CITY OF LA VISTA
MAYOR AND CITY COUNCIL REPORT
JULY 16, 2024 AGENDA

Subject:	Type:	Submitted By:
PUD SITE PLAN AMENDMENT – LOT 2 SOUTHPORT EAST REPLAT TWO	◆ RESOLUTION ORDINANCE RECEIVE/FILE	CHRISTOPHER SOLBERG DEPUTY COMMUNITY DEVELOPMENT DIRECTOR

RECOMMENDATION REPORT

RE: Planned Unit Development Amendment – Initial Review Letter
Lot 2 Southport East Replat Two

C1.0

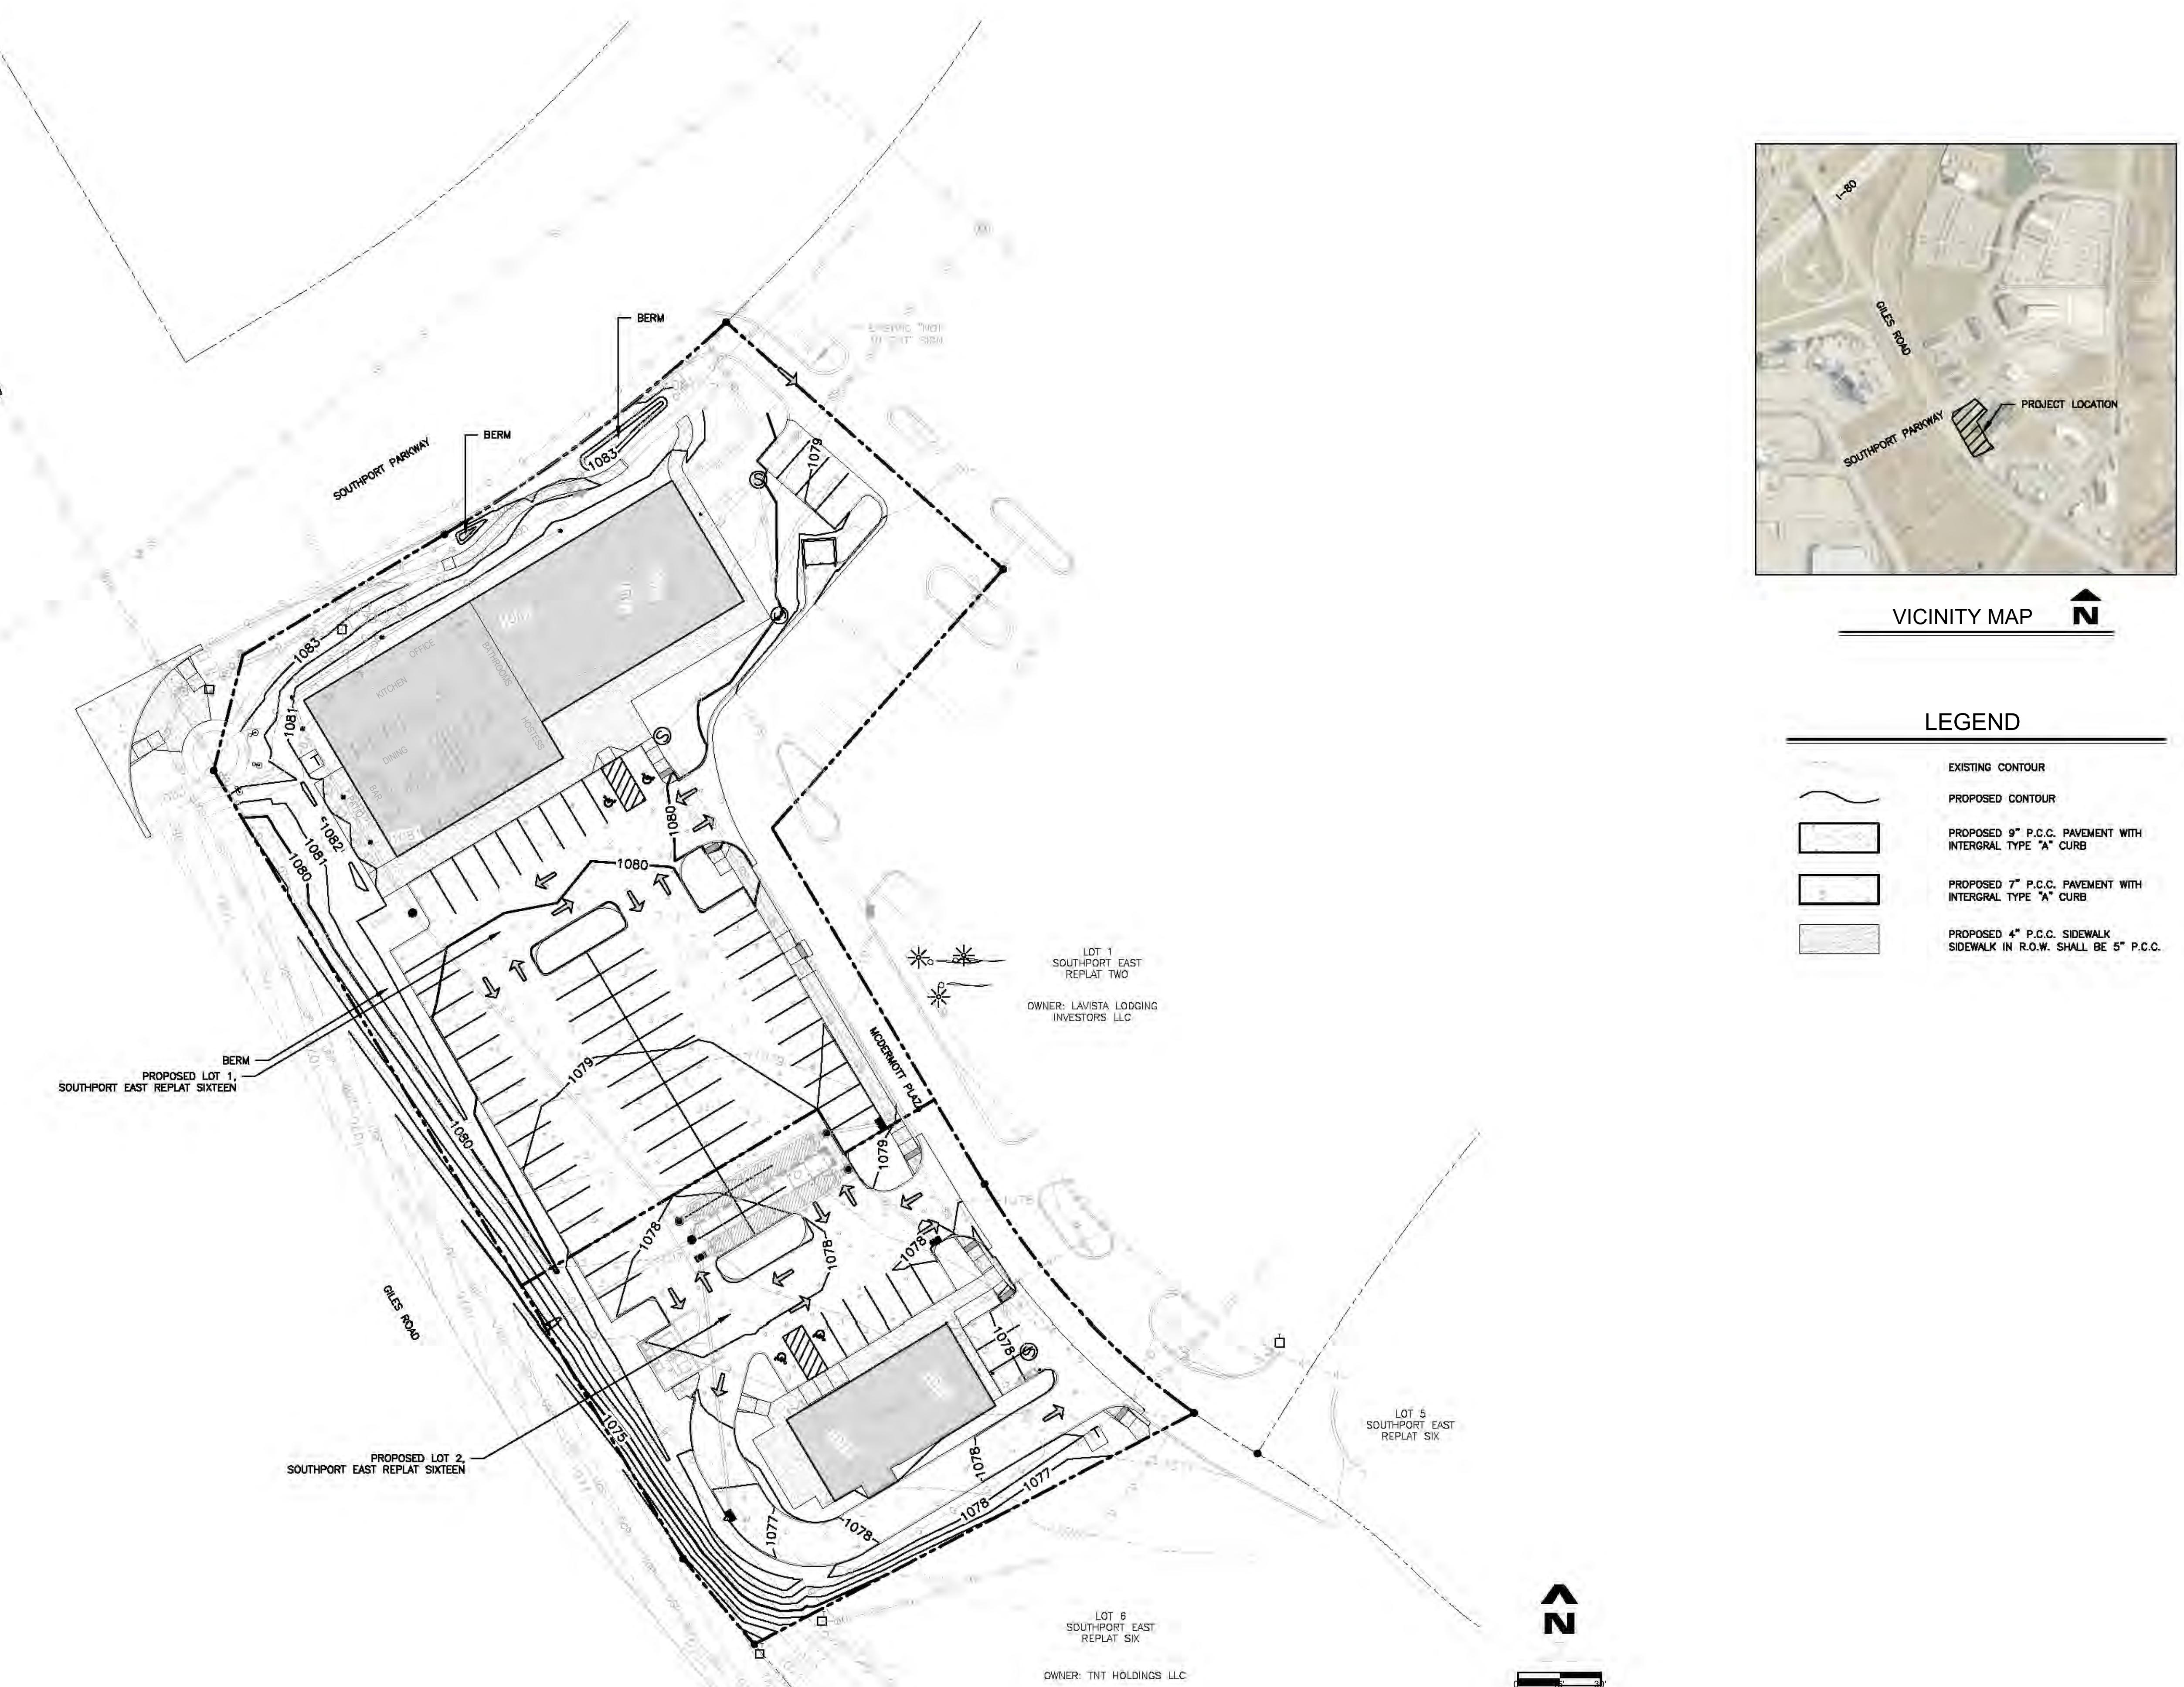
15. Please submit all applicable easements and covenants with neighboring property owners, per Section 5.15.04.03.

16. Please include the heights of all proposed buildings on the project site, per Section 5.15.05.02.2.

17. Please update the legend showing the thickness of all P.C.C. pavement and sidewalks.
18. Please include calculations showing how stall count was determined and if parking stalls will be shared by proposed businesses, per Section 5.15.04.08.

9. The PUD site plan identifies locations for two ground monument signs. Please include the setback dimensions for such signs in the site plan. The required setback for a ground monument sign (advertising a single tenant) is 10 feet. The northwestern-most sign is proposed to advertise both the First Watch restaurant and the general retail tenants, which would make this either a center ID sign or a project directory sign (see Section 7.01 of the La Vista Zoning Ordinance), which each require a 20-foot setback along arterial roads such as Giles Road. If you would like this sign to advertise more than one tenant, then it must be able to meet the 20-foot setback.

C2.0

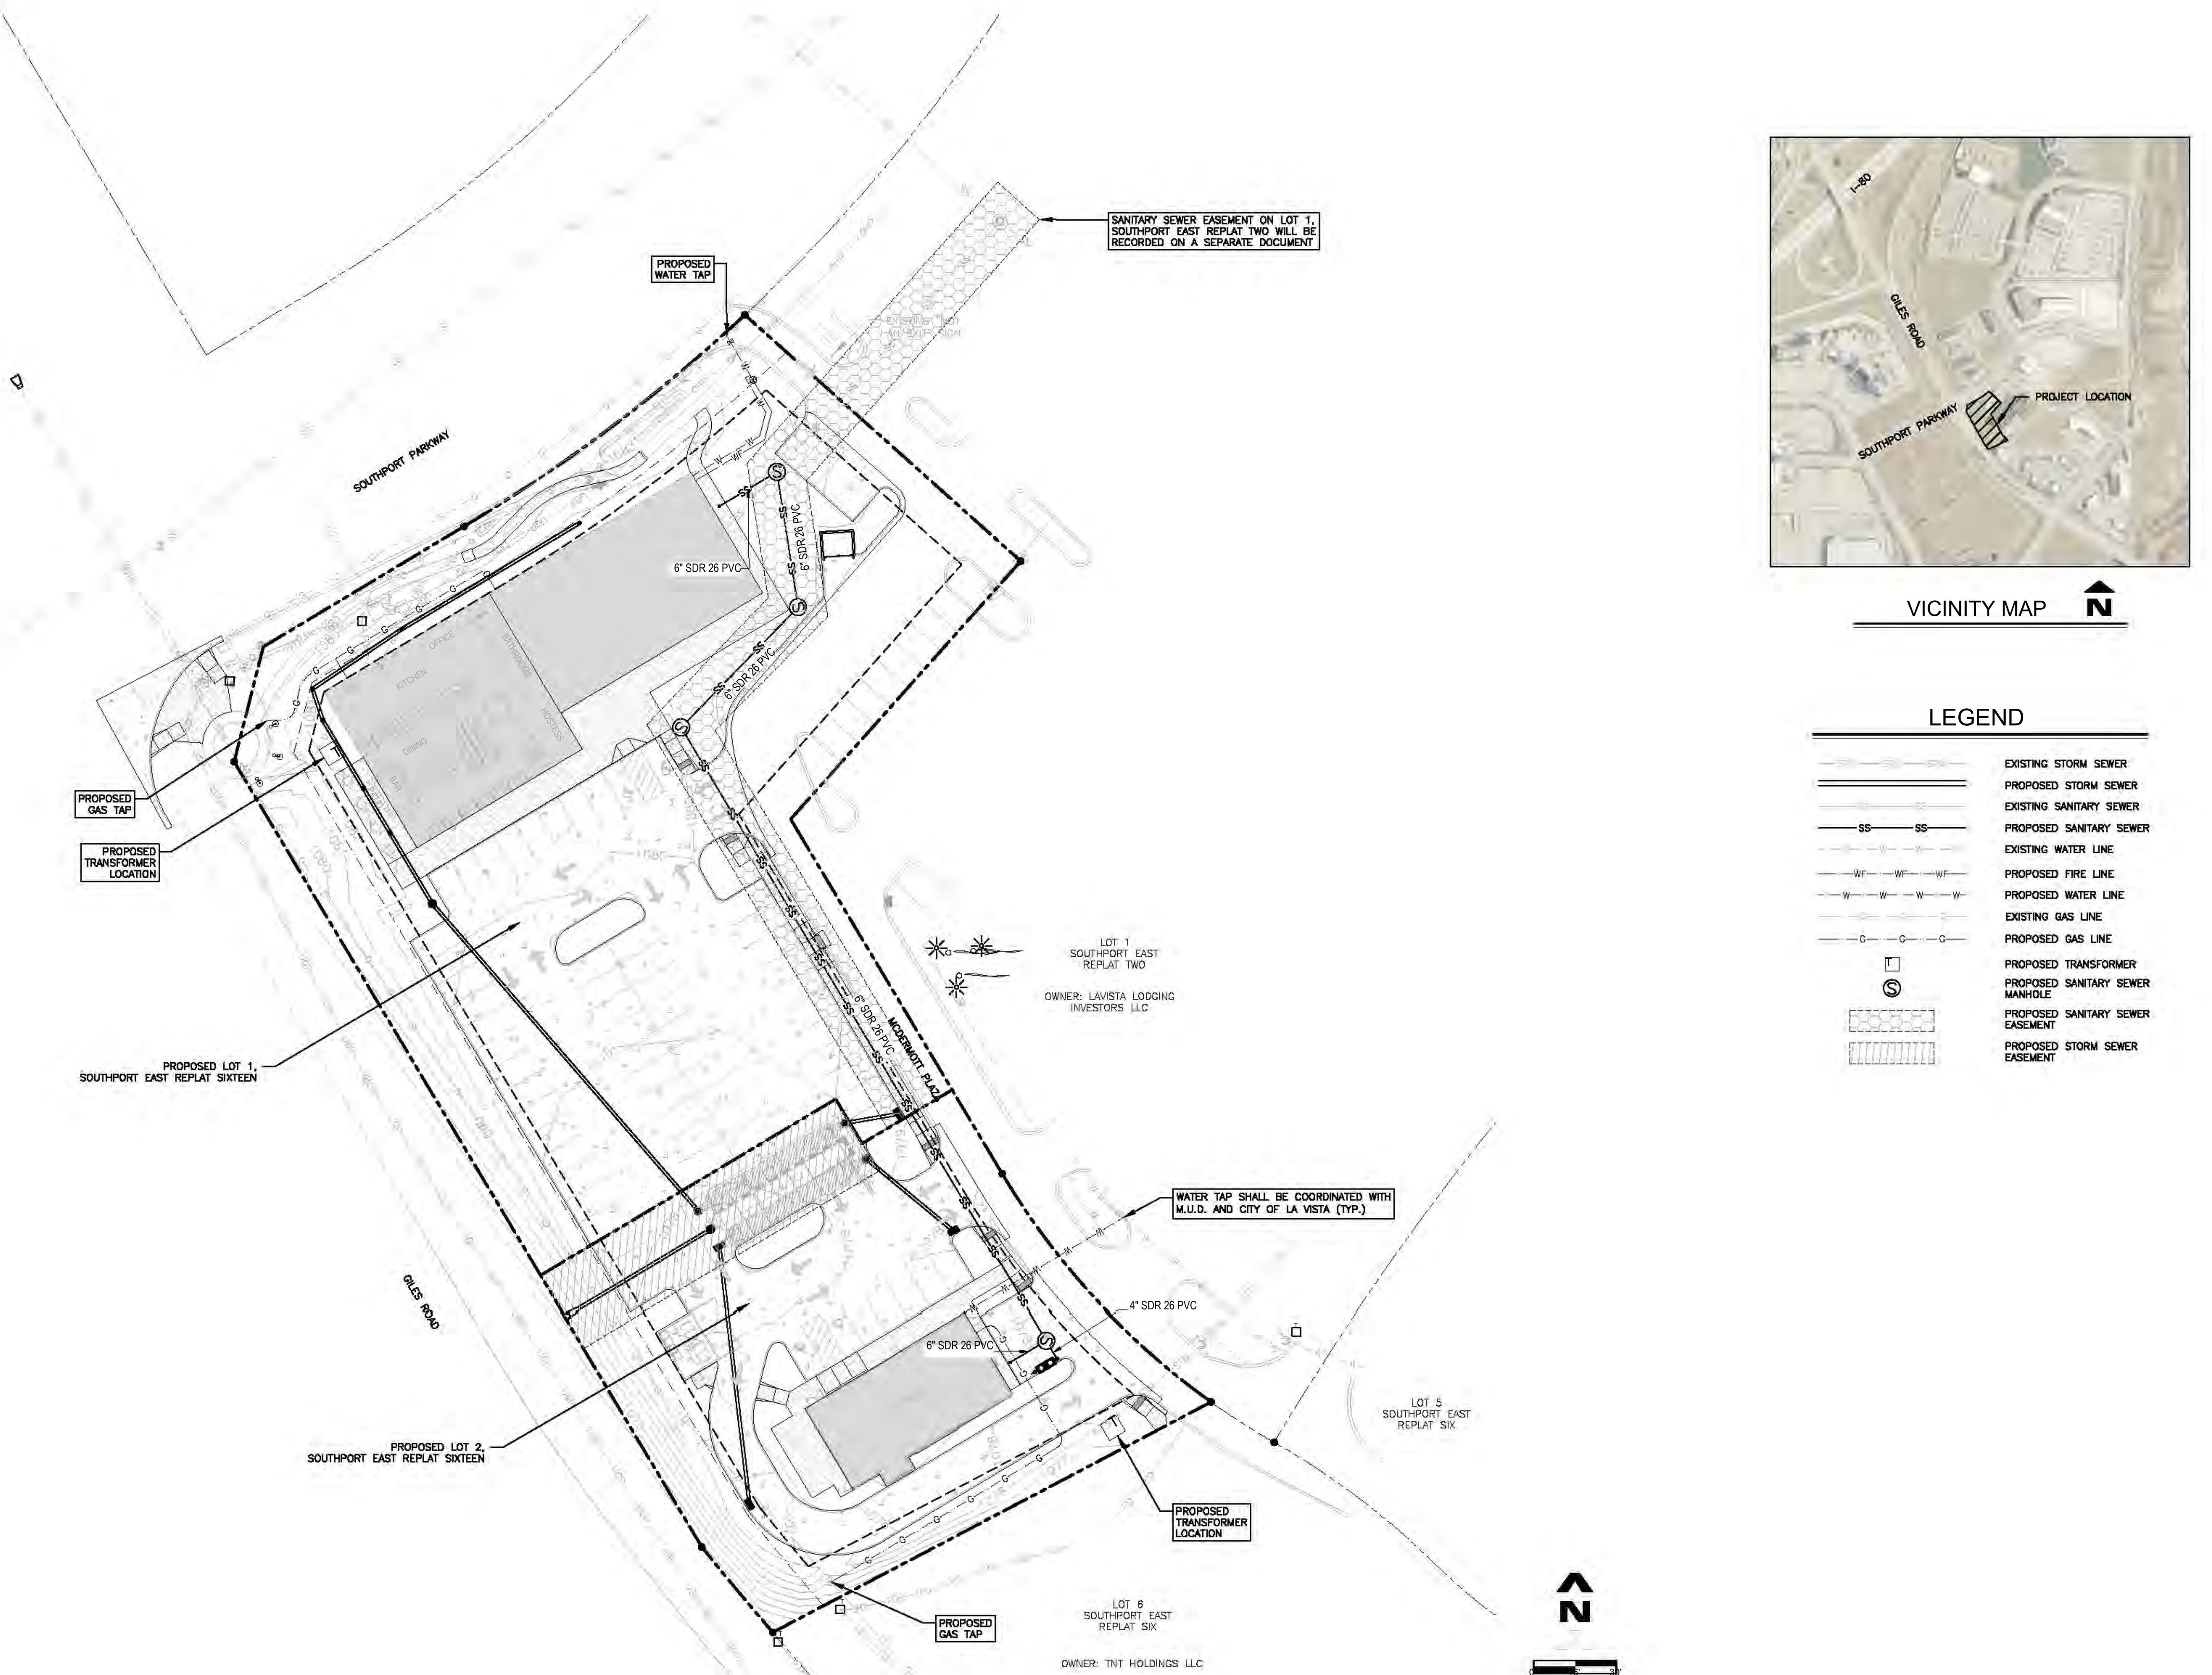
19. Please confirm that grading will not interfere with the drainage swale on the neighboring lot located south of the construction activity.
